### #2014-44 Auto Tech – Special Use Permit Project Review for Planning and Zoning Commission

Meeting Date: November 5, 2014

**Request:** Special Use Permit to allow Automotive Repair, Major for Auto

#### 4. Elevations

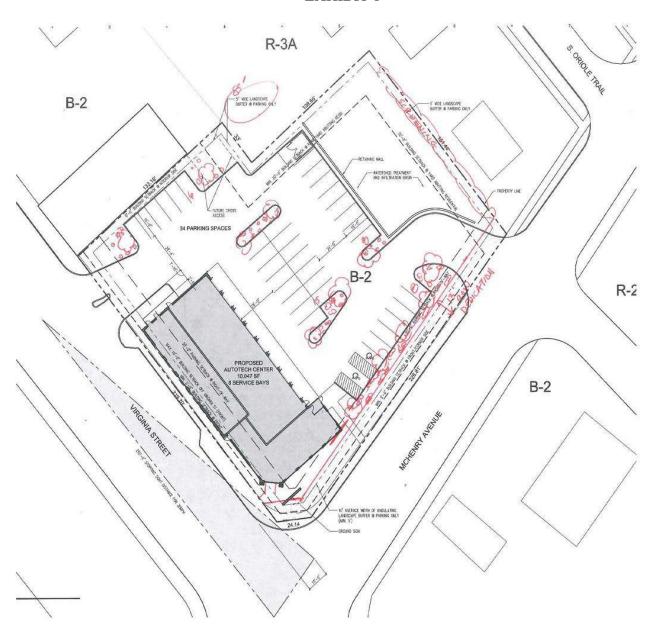
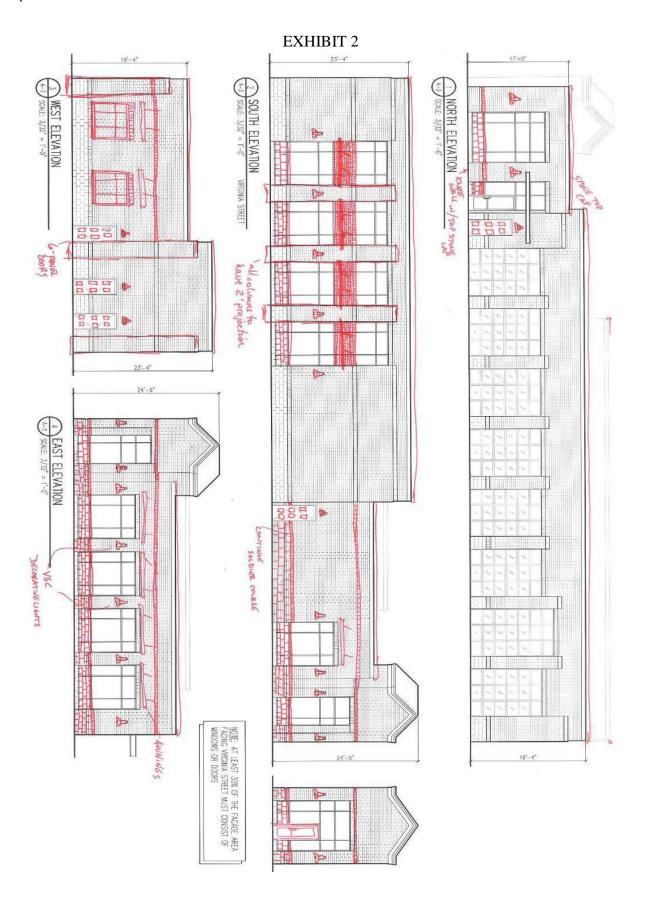
- A. Provide a full knee-wall and increase the bottom block course levels to be at the same height as the soldier course brick.
- B. A public entrance shall be provided from Virginia Street at the corner of the building.
- C. All windows shall be real see-through windows, as opposed to, faux windows.
- D. Exterior metal doors shall be 6-panel decorative doors.
- E. The exterior wall lights shall be a style similar to the VSC lighting standards. Provide wall lighting cut sheets for review.
- F. The soldier course top brick band shall continue along all elevations.
- G. All windows shall have an awning over them. The proposed metal awning over the back public entrance should be duplicated over each window bay.

- H. The large windows along the South elevation shall be broken into two distinct windows with a brick section in between.
- I. Columns shall project a minimum of 2 feet from the face of the building.
- J. The top of the building shall be finished with a top stone cap.

#### EXHIBIT 1

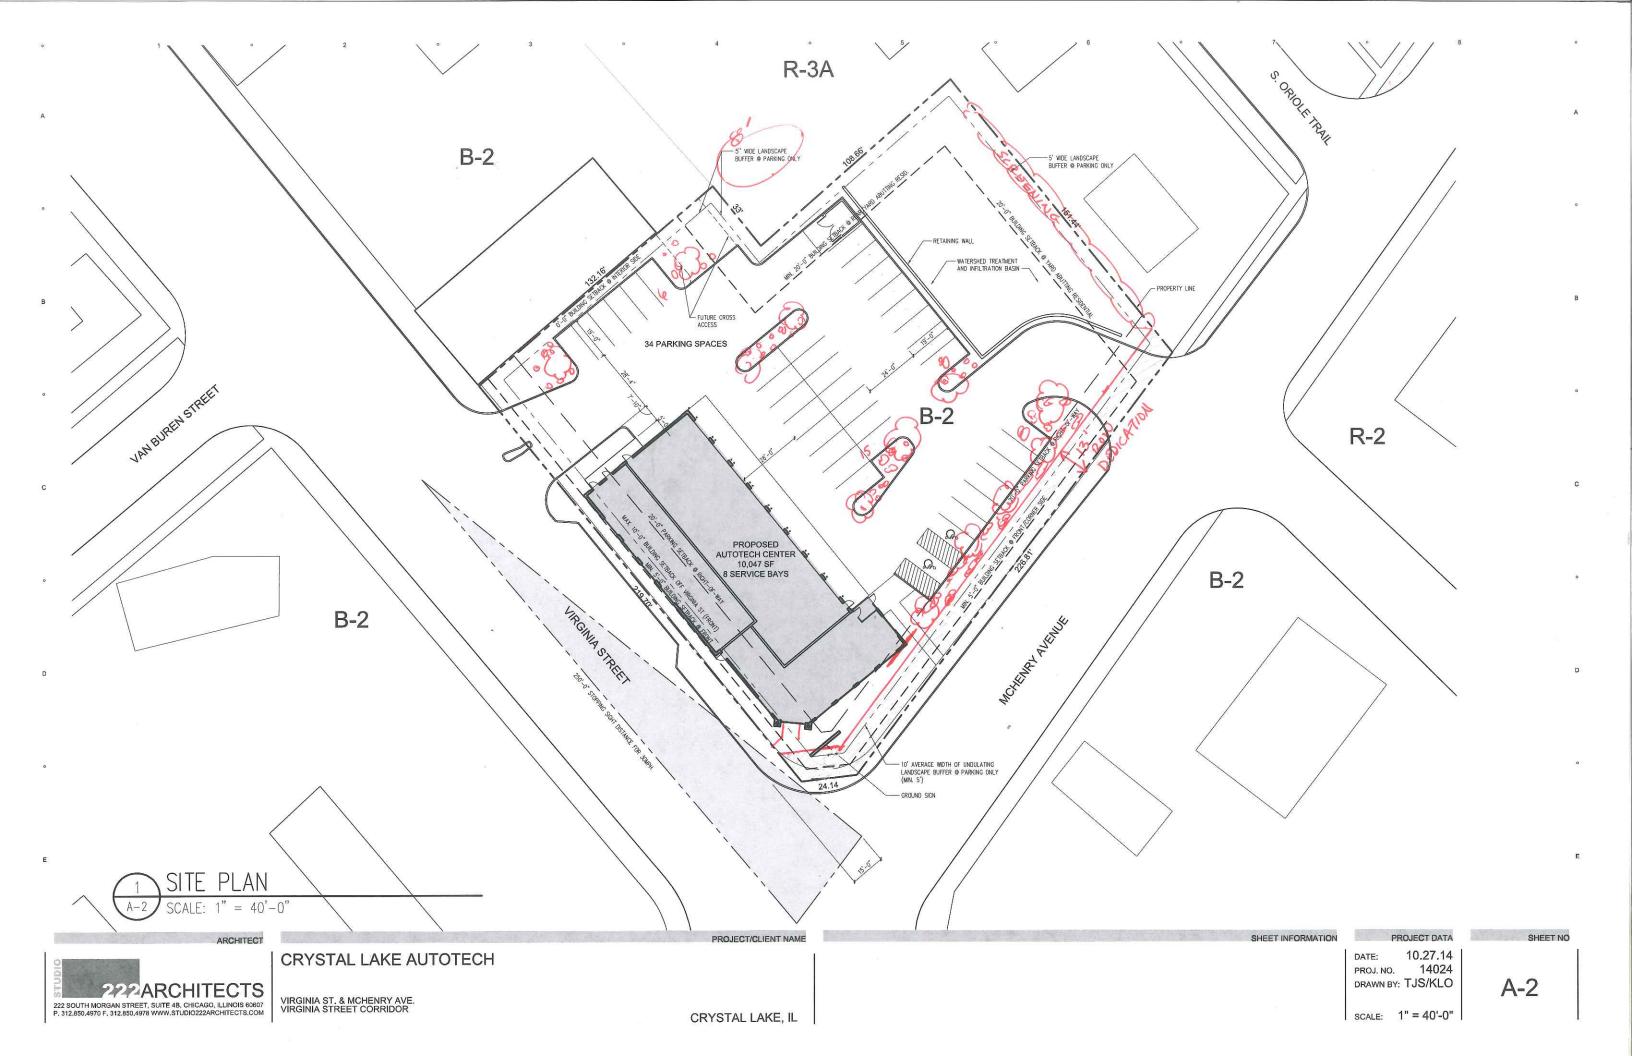
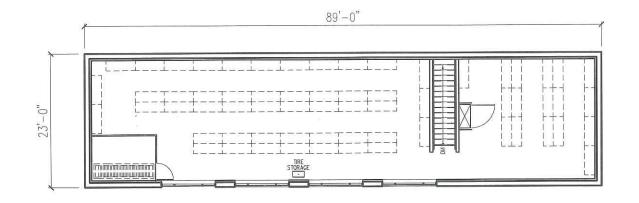
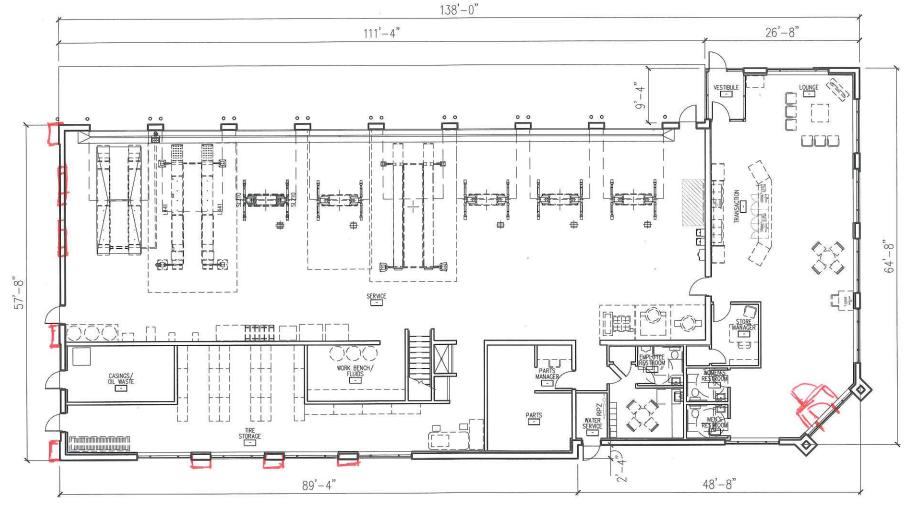
- 1. Approved plans, reflecting staff and advisory board recommendations, as approved by the City Council:
  - A. Application (Edward Miculinich, received 05/30/14)
  - B. Plan Set (Studio 222 Architects, dated 10/27/14, received 10/28/14)
  - C. Engineering Plan (Schmitt Engineering, dated 10/08/14, received 10/28/14)
- 2. Staff has provided recommended revisions to the plans attached as Exhibits 1, 2 and 3.
